Dresden Nuclear Power Station, Units 2 and 3
Facility Operating License Nos. DPR-19 and DPR-25
NRC Docket Nos. 50-237 and 50-249

Quad Cities Nuclear Power Station, Units 1 and 2
Facility Operating License Nos. DPR-29 and DPR-30
NRC Docket Nos. 50-254 and 50-265

Subject: Supplemental Information to Request for License Amendment for Reactor Vessel Low Water Level Setpoint

Dresden Nuclear Power Station, Units 2 and 3
Quad Cities Nuclear Power Station, Units 1 and 2
Reactor Vessel Level Reference Points

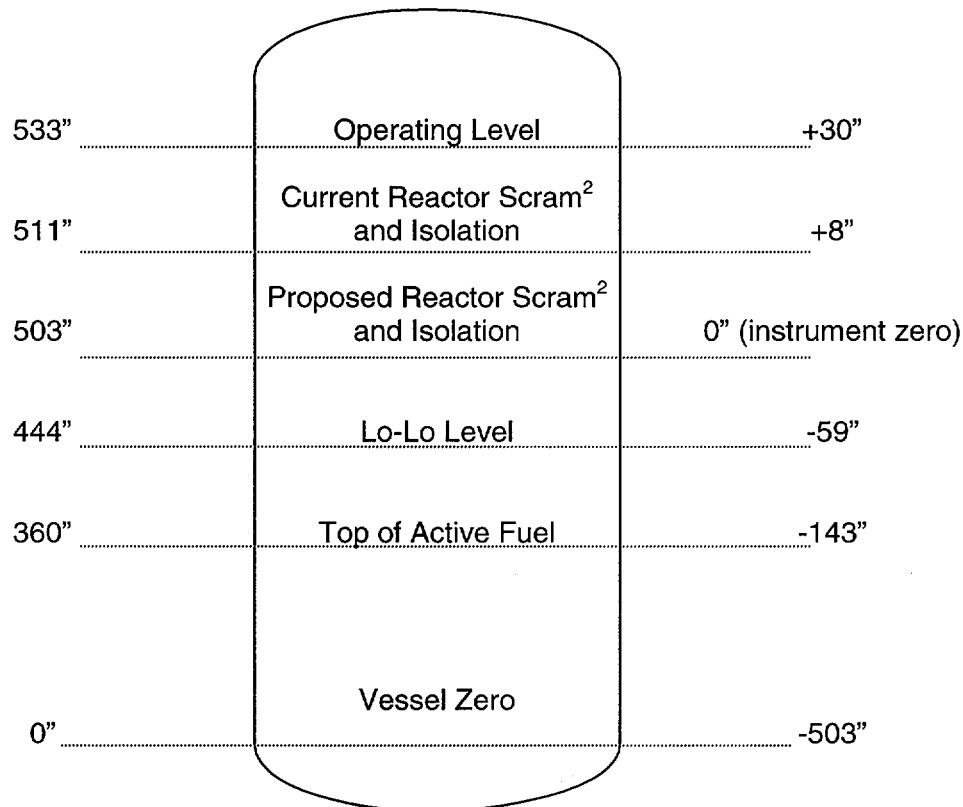
In the referenced letter, the Exelon Generation Company (EGC), LLC, requested changes to the Technical Specifications (TS) for the Dresden Nuclear Power Station (DNPS), Units 2 and 3, and the Quad Cities Nuclear Power Station (QCNPS), Units 1 and 2. The proposed changes reduce the reactor vessel water level – low scram and isolation setpoints. In a discussion between Mr. L. W. Rossbach of the NRC and Mr. A. R. Haeger, the NRC requested that EGC provide additional information regarding these proposed changes. The attachment to this letter provides the requested information.

1. The values in the column labeled "inches relative to instrument zero reactor water level" are based on water level outside the core shroud. The water level inside the core shroud decreases in comparison to the water level outside the core shroud to a maximum of approximately seven inches as power is increased to 100% power due to the pressure drop across the steam dryer. Therefore, at 100% power, an indicated reactor water level of + 8 inches corresponds to a reactor water level of approximately +1 inches inside the core shroud. The transient analyses account for this level difference.
2. The analytical limits for the current and proposed low reactor water level scram and isolation are +8 inches and 0 inches respectively. The corresponding allowable values for Dresden Nuclear Power Station and Quad Cities Nuclear Power Station are provided in the License Amendment Request.
